**Subject: Cell 4 – Green-Croissant Pit  
Reclamation Slope Evaluation Version 2**

- Corrects typos, and mis-interpretation of the Rule to address comments by DRMS (Hays, 2022)
- Summarizes our evaluation of the existing reclamation slopes at the above referenced mine cell
- Compares our analysis to that provided by Ms. McGill (McGill, 2021)
- Evaluates the Division of Reclamation, Mining and Safety's (DRMS's) correspondence intimating a regrade requirement of Zones 9, 20, 25, 26 and part of 27 (Hays, 2021)

**CELL 4  
GREEN-CROSSANT PIT  
RECLAMATION SLOPES  
KING SURVEY  
COMPARISON**

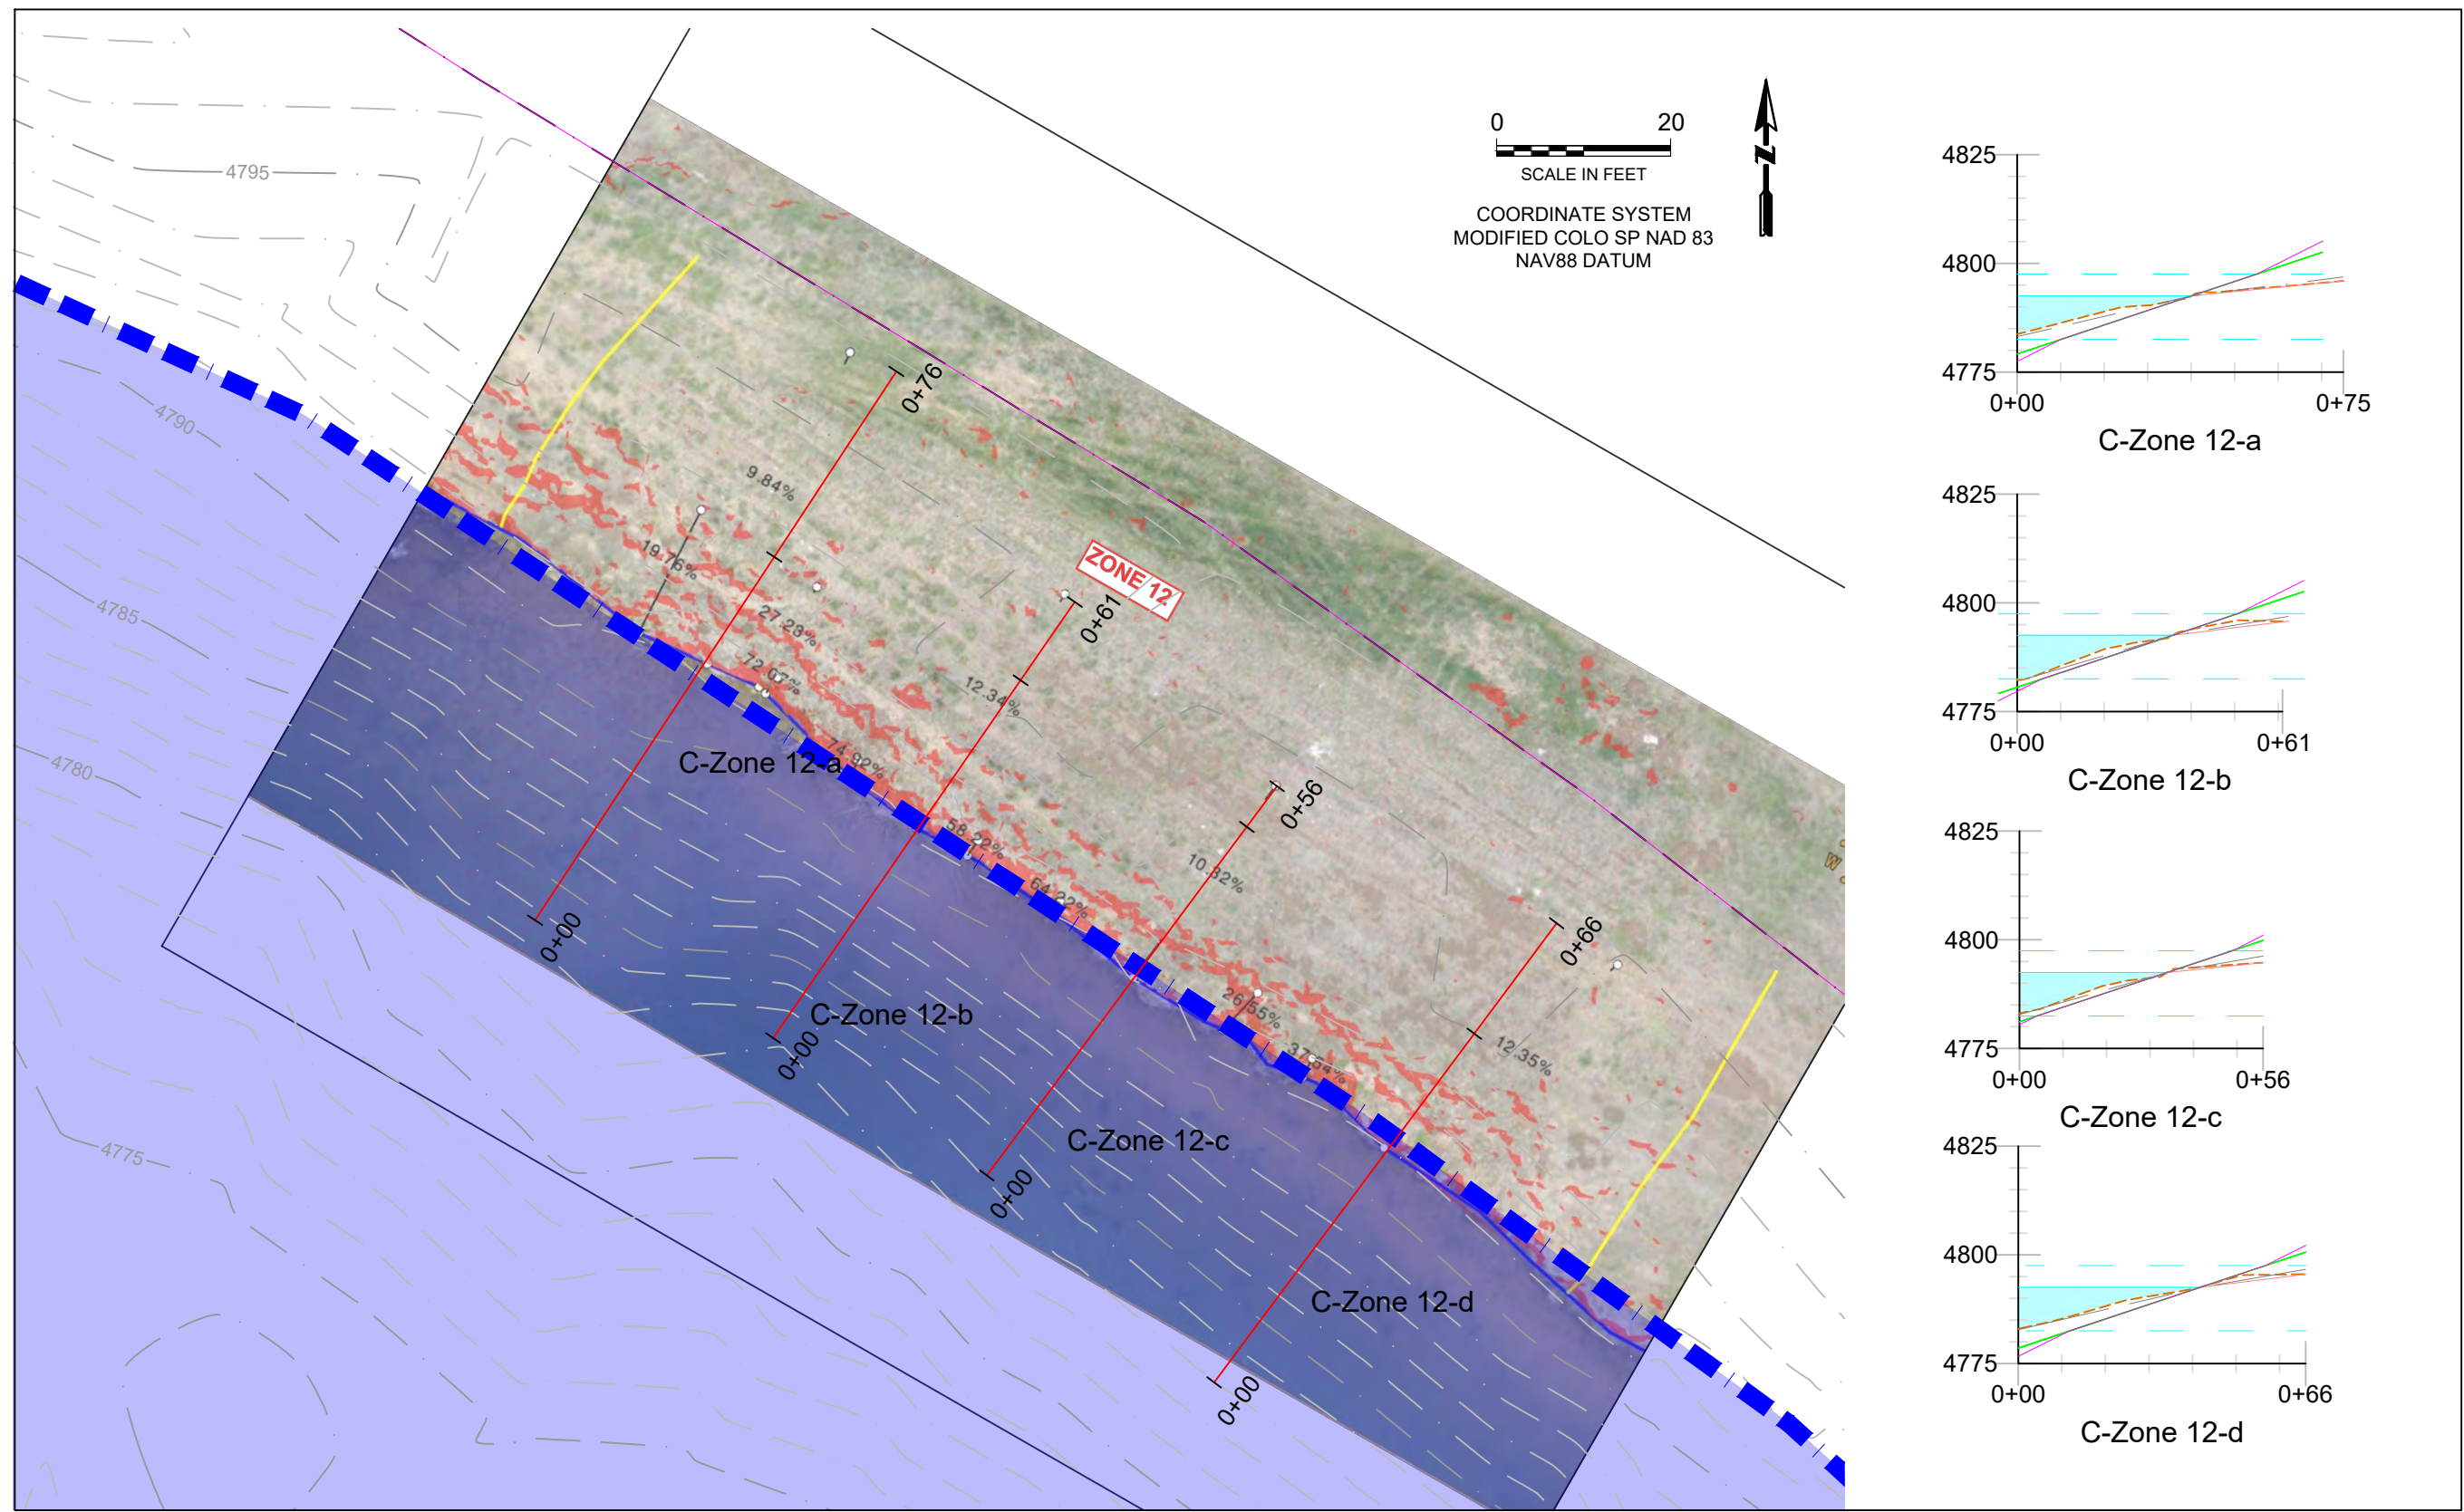
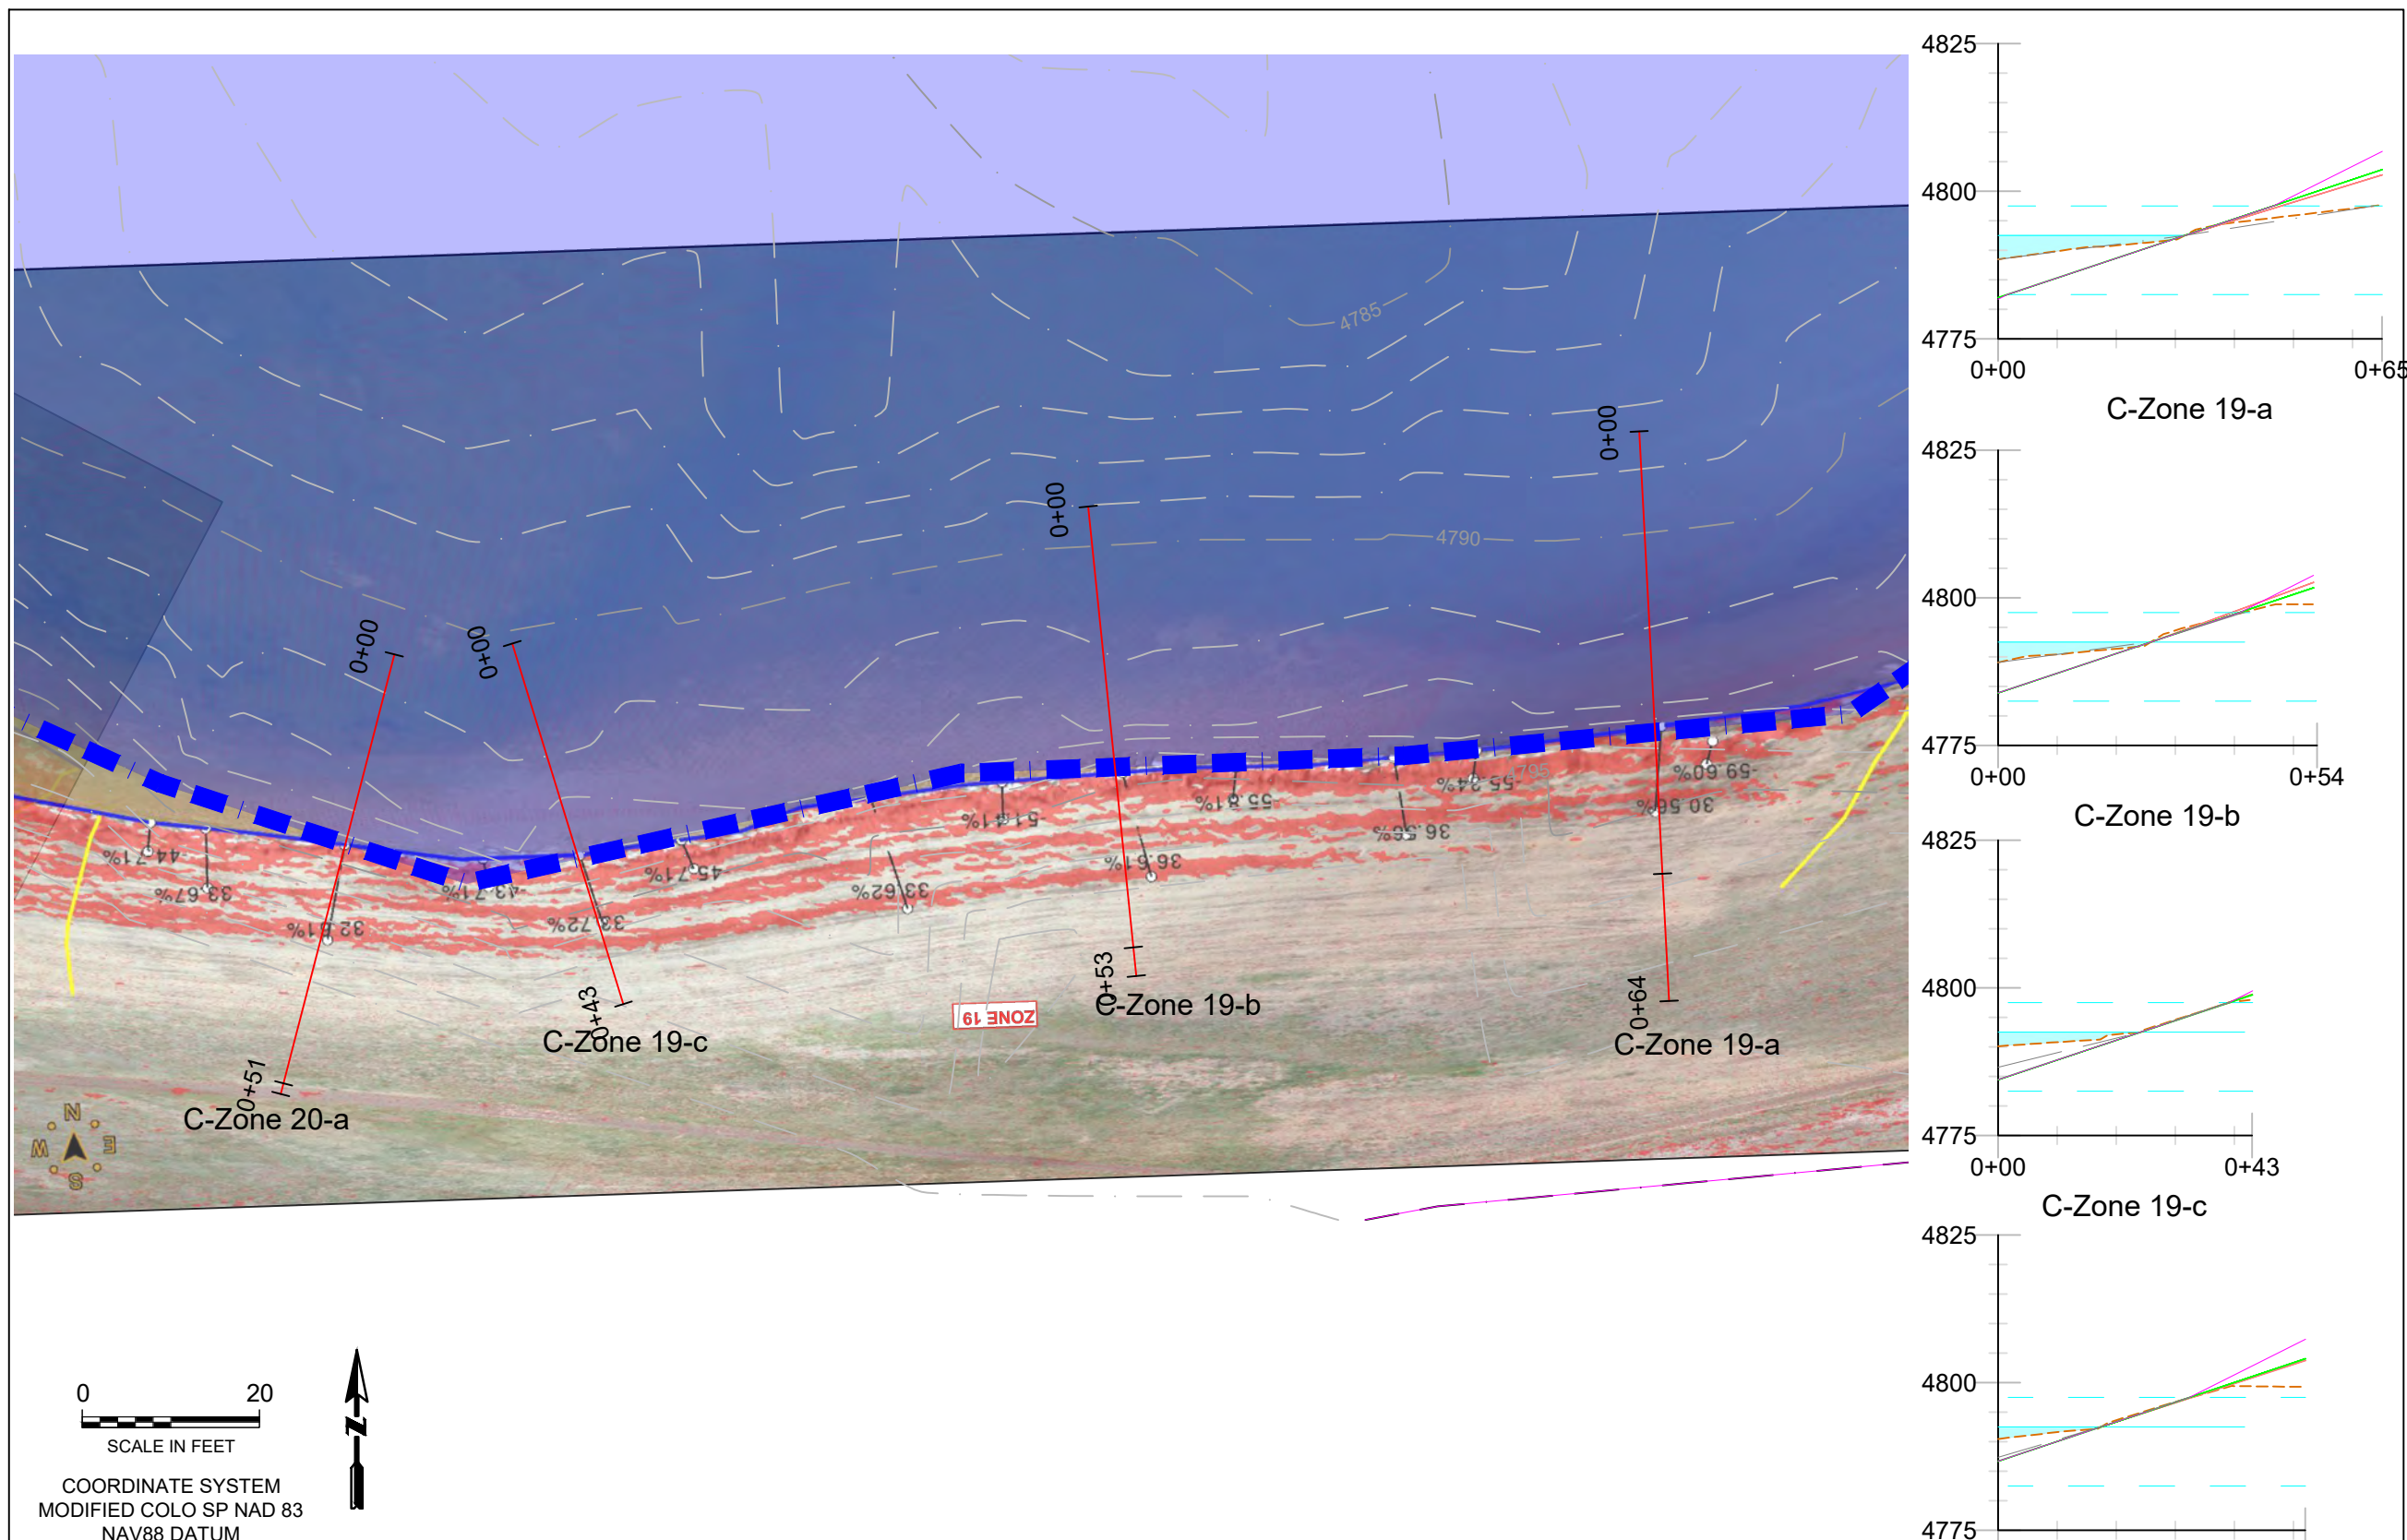
We chose Zones 12, 19 and 20 for comparison purposes. The King Survey shows, generally, that slopes in Zone 12 are gentle, Zone 19 are right at Rule slopes, and Zone 20 is steeper. This allowed a range of slope estimation comparison. We overlaid the images provided in the King Survey that showed their slope estimates into AutoCad. We then placed sections, perpendicular to the topographic contours near the King Survey evaluation locations and repeated the process described in the previous section. We placed the cross sections such that King's point closest to the water's edge runs through the cross section. Then on each cross section, we plotted King's reported slope by percentage. We also repeated the comparison in Zone 25 at the maximum slope indicated by King.

Most of the reported slopes in the King Survey were too short and biased by local irregularities (e.g., plow lines from drill seeding and cross ripping placed for soil retention and seed germination) for us to use in comparison. To calculate slopes, the approach should utilize the Rule's slopes 5 feet above and 10 feet below the water surface. Thus, we used the few King Survey slope calculations that were of appropriate length in our comparison. Sheet 2 summarizes the comparison between the King Survey and the PLS Corporation survey and our interpretation. Zones 12 and 19 show that the beginning and ending points the King Survey used for slope calculations generally agree with the PLS Corporation survey. In Zone 20, the King Survey shows slightly steeper slopes than those based on the PLS Corporation survey. The information provided on the King Survey (McGill, 2021) is in PDF format with no vector information, and some of the images appeared to be at a skewed angle. This could account for some of the discrepancy between the surveys in that the section location we attempted to mimic could be off slightly.
